**Job Title:** The London Irish Centre  
**Date:** 12<sup>th</sup> August 2020

**Subject:** Response to Comments raised by Transport for London

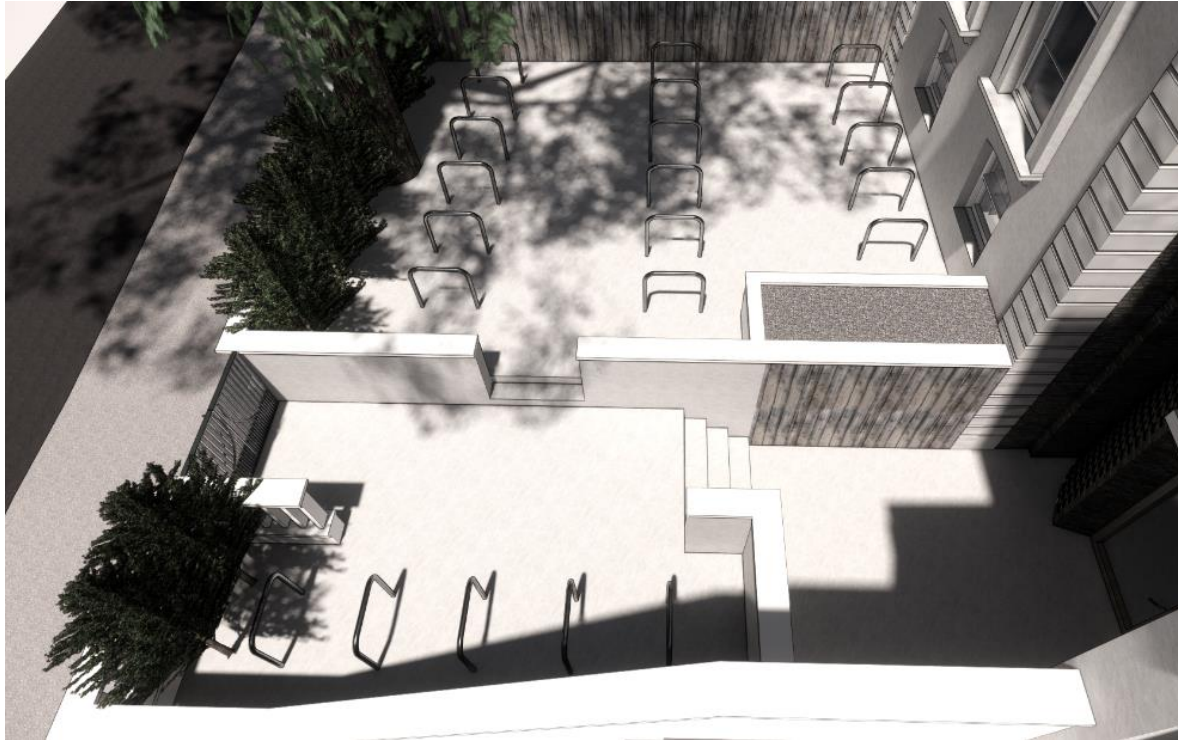
6. *Whilst the level of long stay cycle parking proposed is welcome, TfL requests the level of short stay cycle parking is increased to meet new London Plan policy T5 (Cycling) minimum standards.*

Although it is noted that there is a small shortfall in short stay cycle parking, the submitted Transport Statement suggested that the additional Long Stay spaces (more than what policy requires) could be made available via Centre Management if demand for the short stay spaces exceeds capacity. This could be managed via the site's Travel Plan.

Nevertheless, following receipt of the comments, a review of the short stay cycle parking has been undertaken and an additional four spaces provided. This provides a total of 44 spaces which is three below what planning policy requires, however, facilitating the additional spaces would compromise access into the building at this location.

This is something that can be looked at further, and it is considered this could be appropriately addressed by way of a suitably worded planning condition, if required. However, it is pertinent to note that the total number of cycle parking spaces (long + short stay) meets planning requirements. The proposed short stay spaces are shown in the image below:
